Typical details: where CAD and Revit draw the same detail differently

55 of the 190 CAD typical details have a Revit version in your templates that is drawn differently.

Compared by eye on 2026-10-23 from Nelson's CAD blocks and the Concrete Tower R24 / Steel R24 / Container R23 templates.

CAD: KOR-D201-DET 02 - TYPICAL DETAIL AT JUNCTION OF 48 TO 36 DEEP RAFT

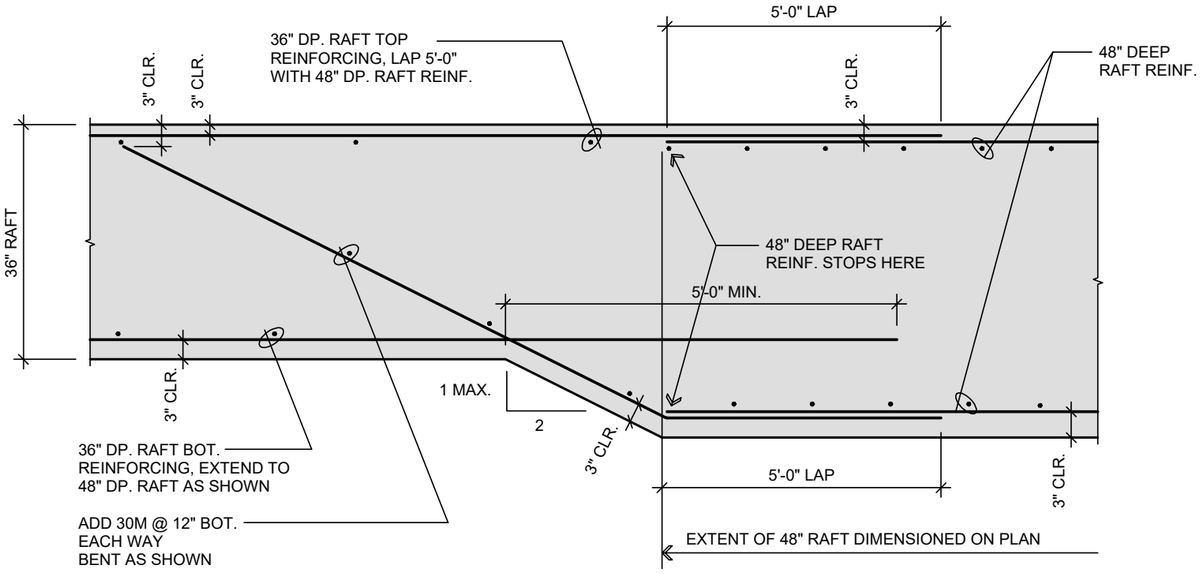
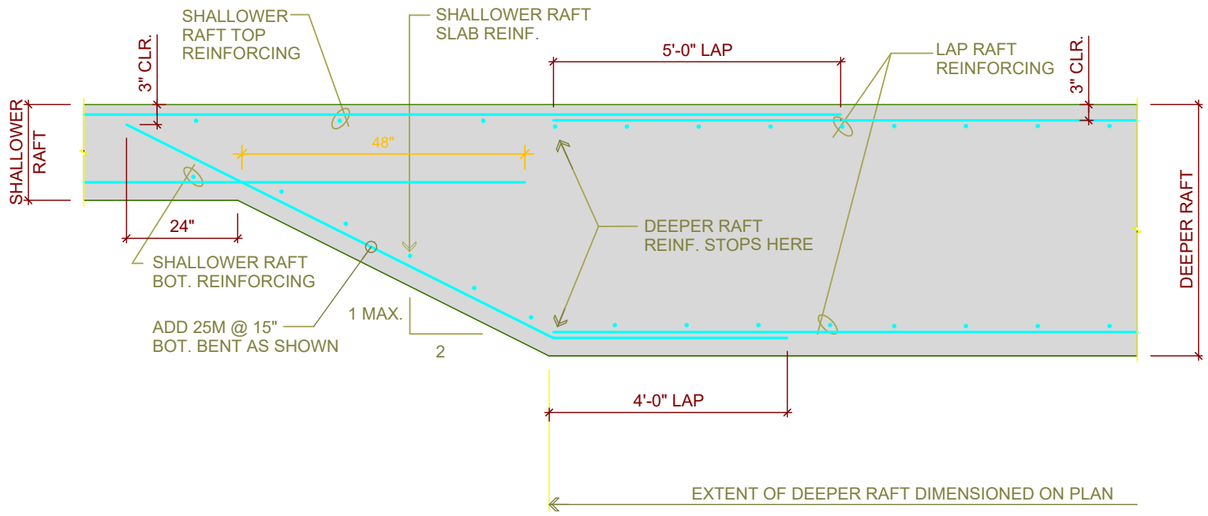
What differs: 48-to-36 junction version of the sloped raft transition; adds 48-in deep reinf callouts and a 30M bent bottom bar vs generic 'D2.01_1_TYPICAL CHANGE IN RAFT SLAB THICKNESS'.

CAD: KOR-D201-DET 03 - TYPICAL BASEMENT WALL

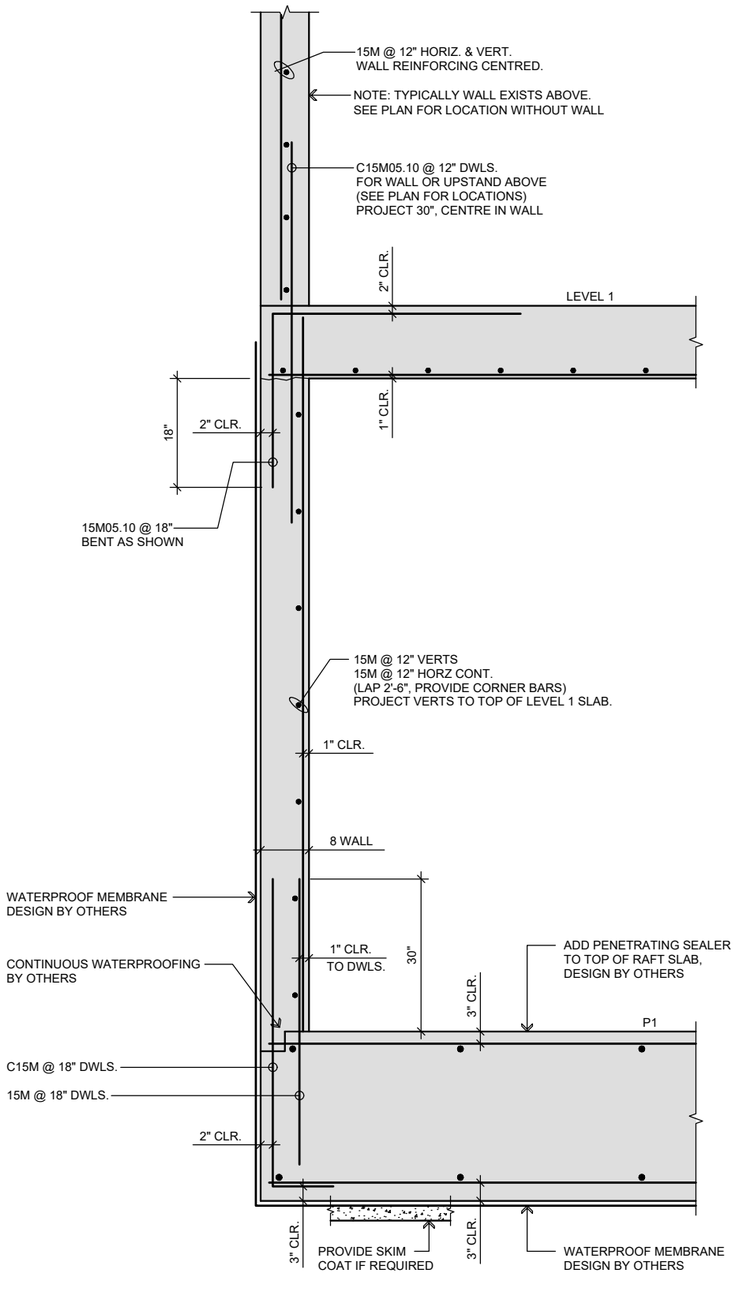
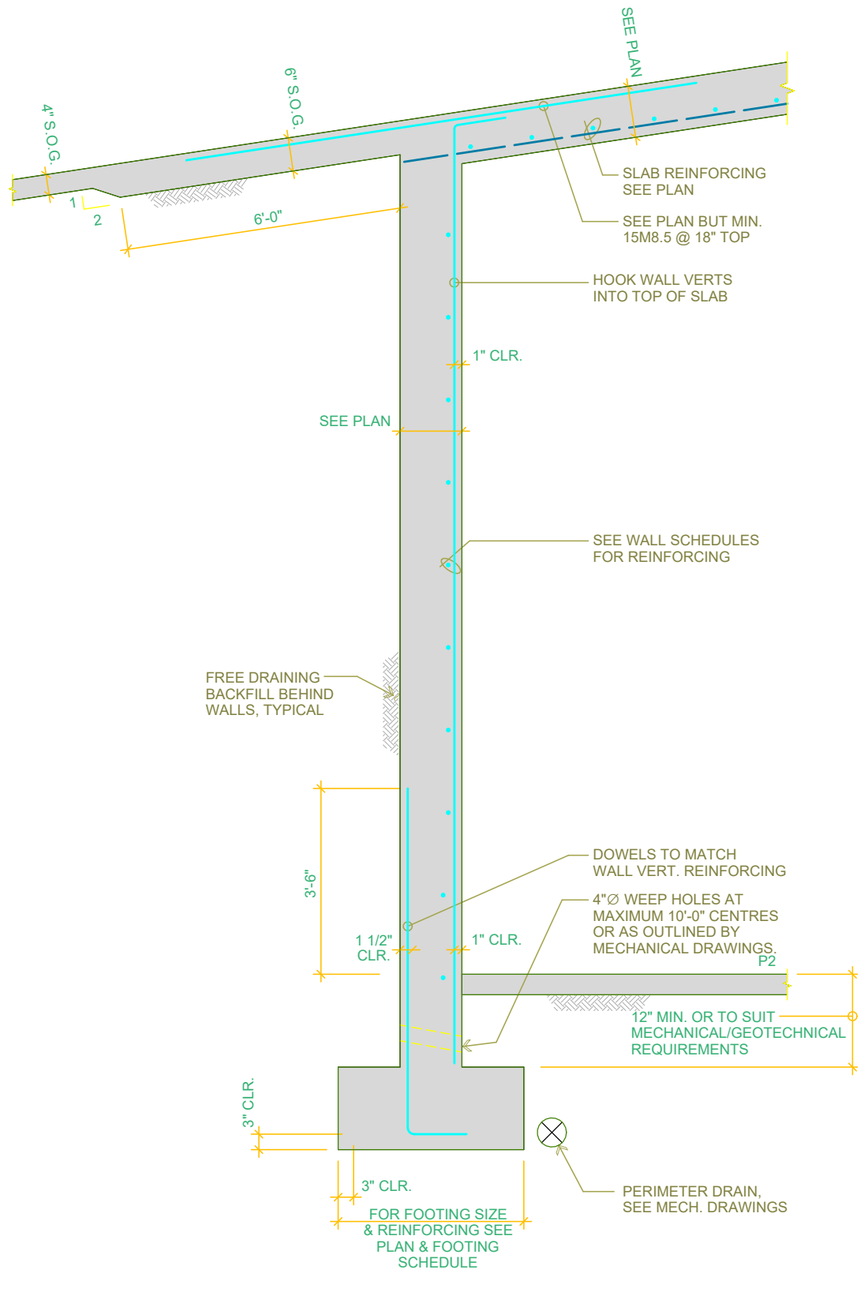
What differs: CAD is a basement wall running from suspended slab down into the raft with an intermediate slab; 'S5.05_1_BASEMENT WALL DETAIL' is a wall with sloped slab over and strip footing.

Revit: D5.01_1_TRENCH DRAIN ON GRADE DETAIL (Typical Details - Container_R23 (Need_MET & IMP).rvt; on D5.01 Series 5 Miscellan)

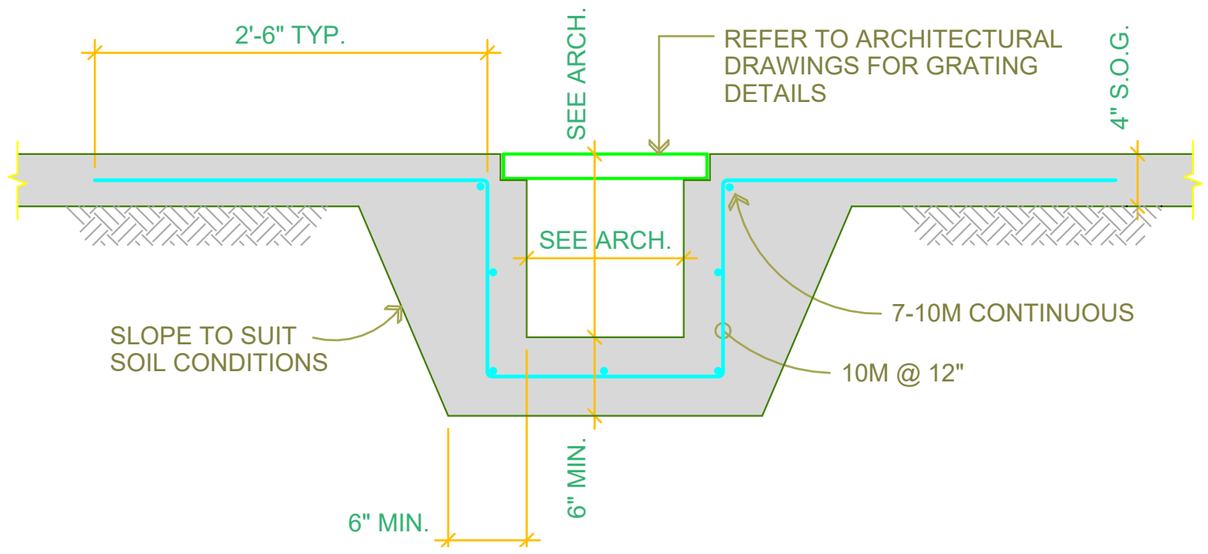
What differs: CAD is a trench drain in a thickened raft with 20M bars; 'D5.01_1_TRENCH DRAIN ON GRADE DETAIL' is the on-grade thickened trench of the same shape but different slab and bars ('D5.01_2_TRENCH DRAIN ON RAFT DETAIL' is a topping-on-raft trench).

CAD: KOR-D201-DET 11 - TYPICAL PIT IN STRUCTURAL SLAB

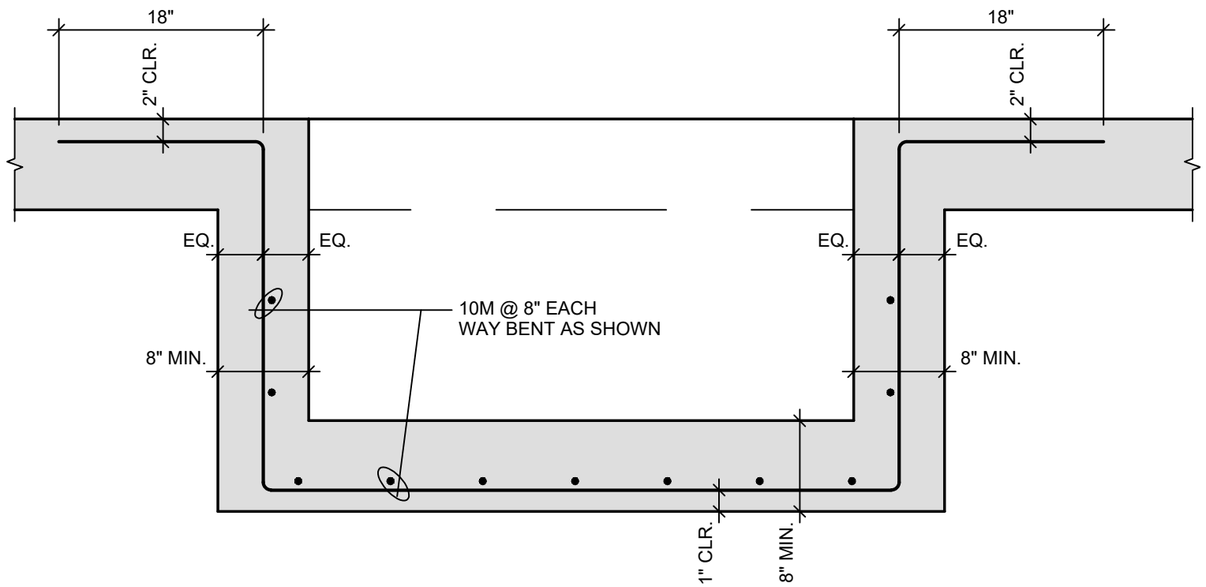
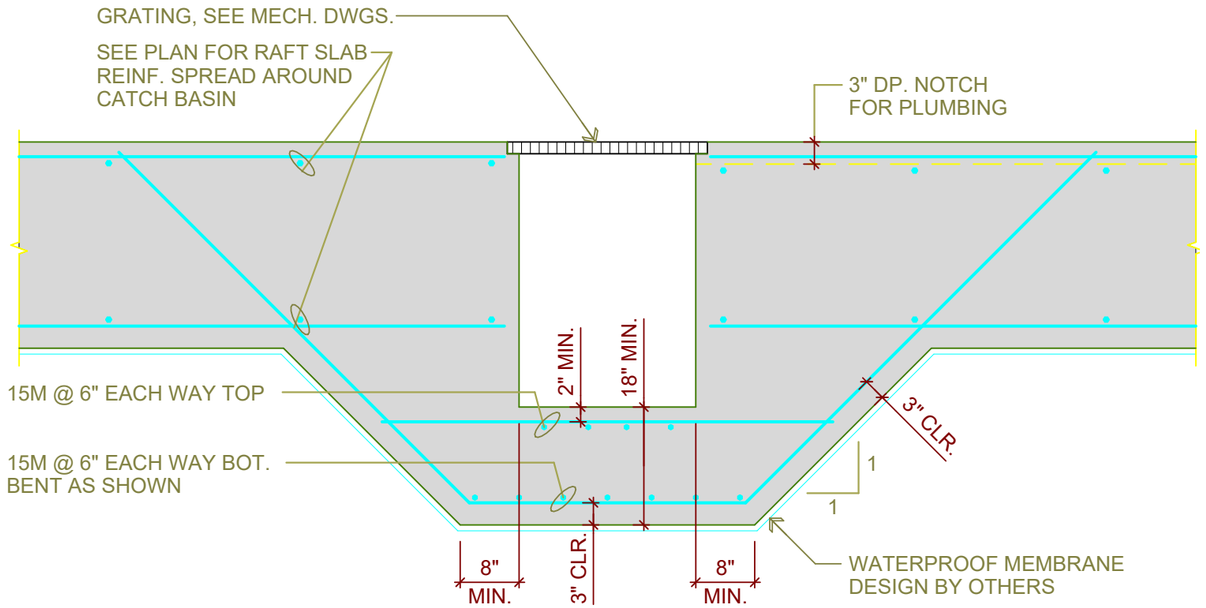
What differs: CAD is a square-sided pit dropped into a structural slab with 10M bent bars; 'D2.01_3_TYPICAL DETAIL AT CATCH BASIN OR SUMP IN RAFT SLAB' is a sloped-sided catch basin sump in raft - same purpose class, different shape and bars.

CAD: KOR-D202-DET 02 - TYPICAL SECTION THRU CORE FOOTING AT ELEVATOR PIT

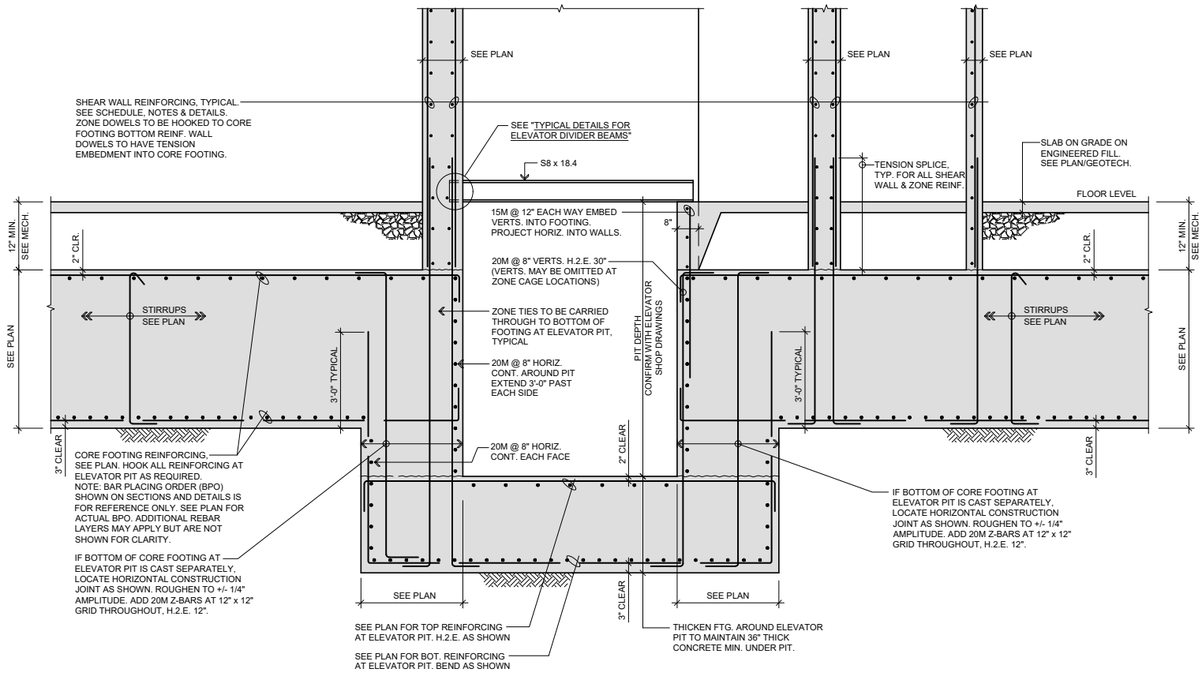
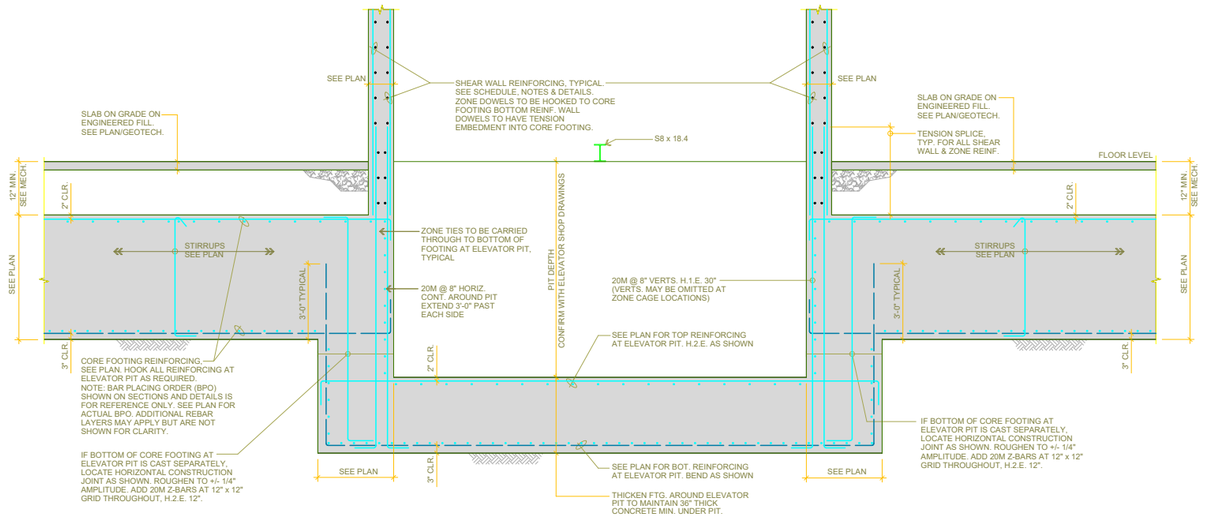
What differs: Core footing at elevator pit with a divider beam and extra horizontal bar callouts not in 'S6.01_2_CORE FOOTING SECTION THRU ELEVATOR PIT'.

CAD: KOR-D202-DET 03 - TYPICAL SECTION THRU CORE FOOTING AT ELEVATOR PIT

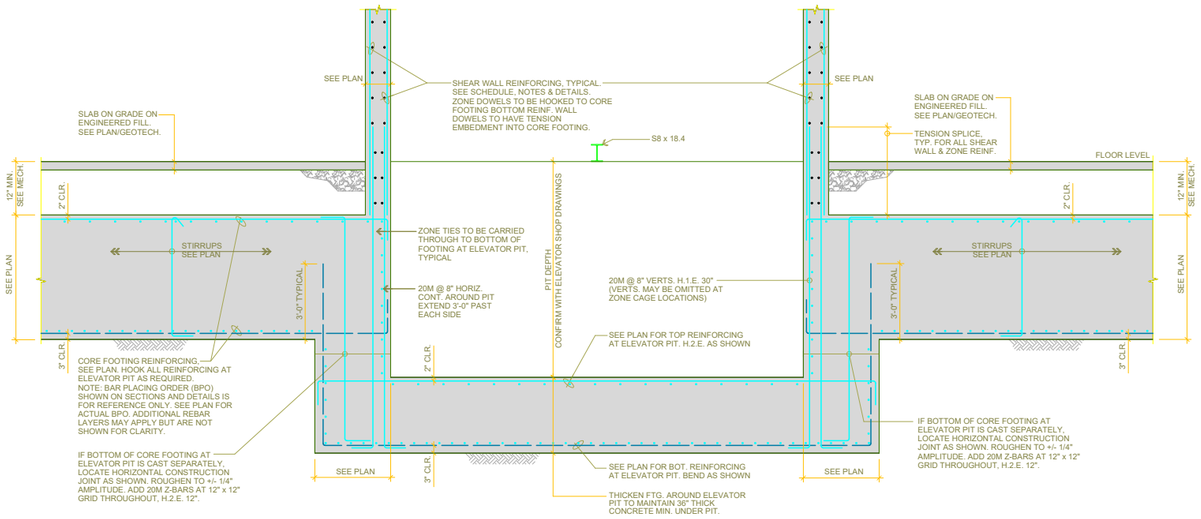
What differs: Core footing at elevator pit variant: flat footing with thicker pit slab, fewer callouts than 'S6.01_2_CORE FOOTING SECTION THRU ELEVATOR PIT'.

CAD: KOR-D202-DET 04 - TYPICAL SECTION THRU CORE FOOTING AT ELEVATOR PIT

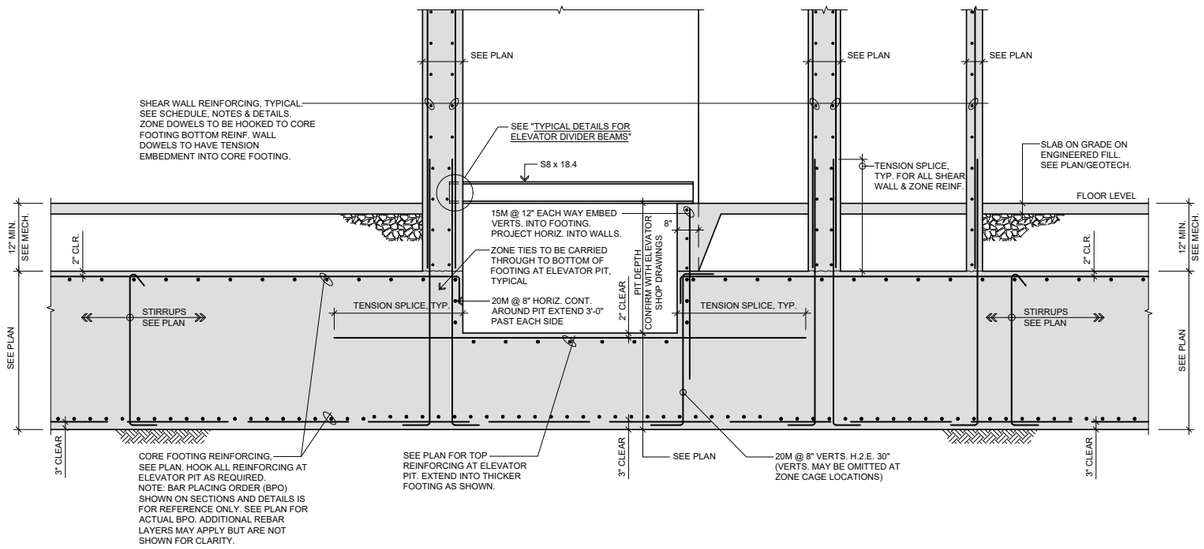
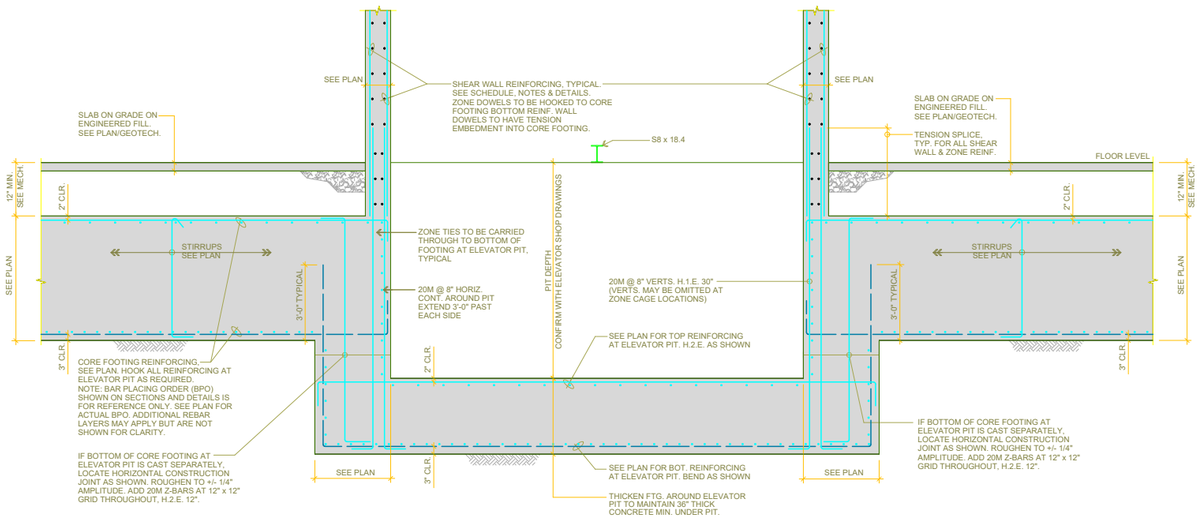
What differs: Core footing at elevator pit variant with an extra divider wall/beam and pit slab arrangement not in 'S6.01_2_CORE FOOTING SECTION THRU ELEVATOR PIT'.

CAD: KOR-D202-DET 07 - TYPICAL SECTION THRU CORE FOOTING AT ELEVATOR PIT

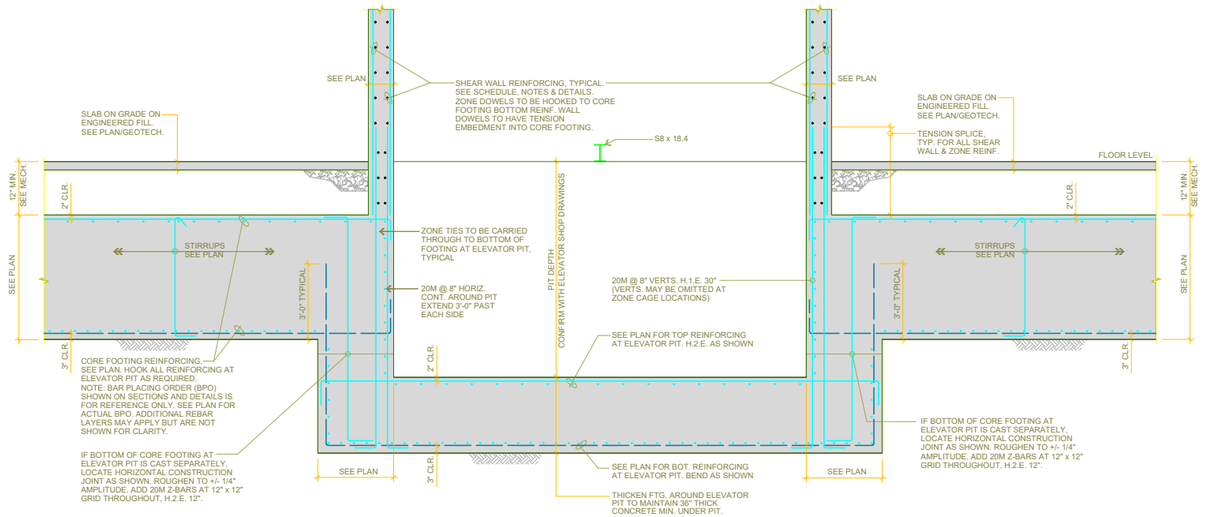
What differs: Core footing with sloped (haunched) sides to the deeper pit; 'S6.01_2_CORE FOOTING SECTION THRU ELEVATOR PIT' has vertical steps.

CAD: KOR-D202-DET 08 - TYPICAL SECTION THRU CORE FOOTING AT ELEVATOR PIT

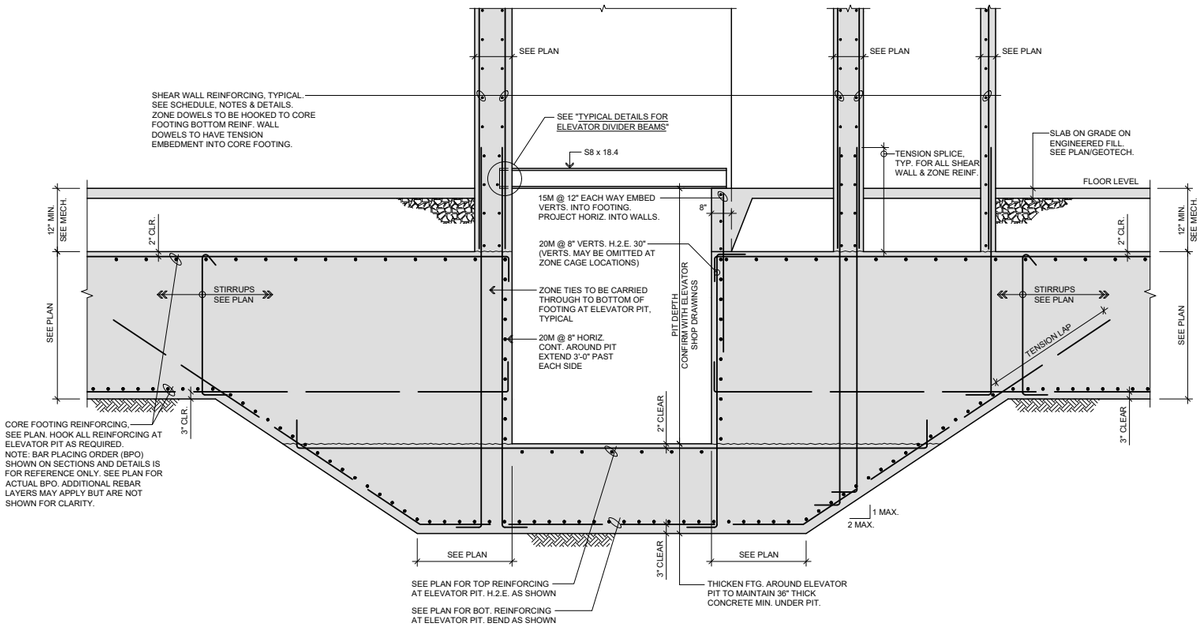
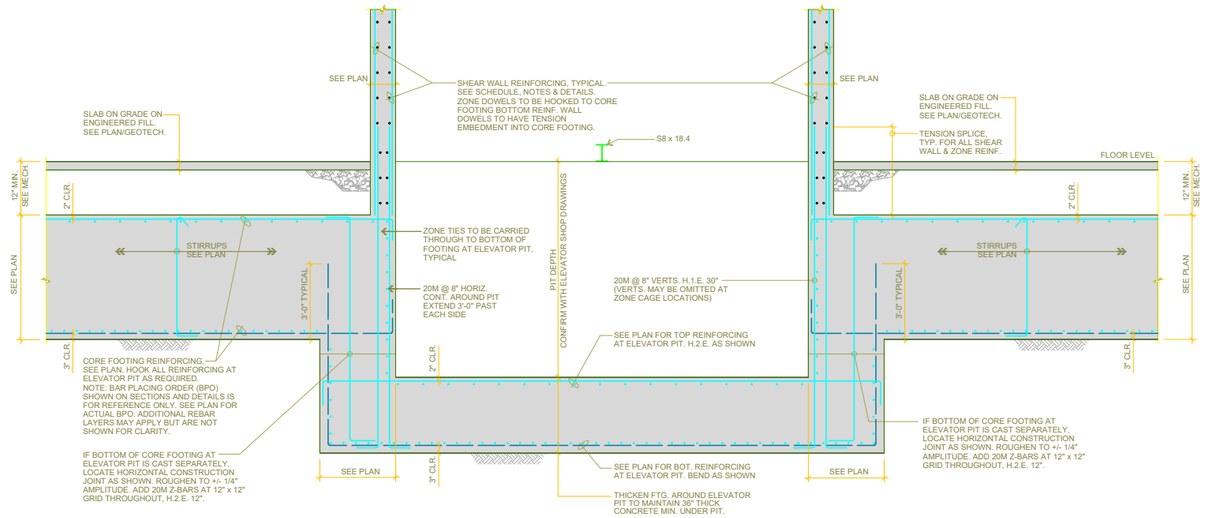
What differs: Core footing with sloped sides, divider beam and lap notes; 'S6.01_2_CORE FOOTING SECTION THRU ELEVATOR PIT' has vertical steps and no divider.
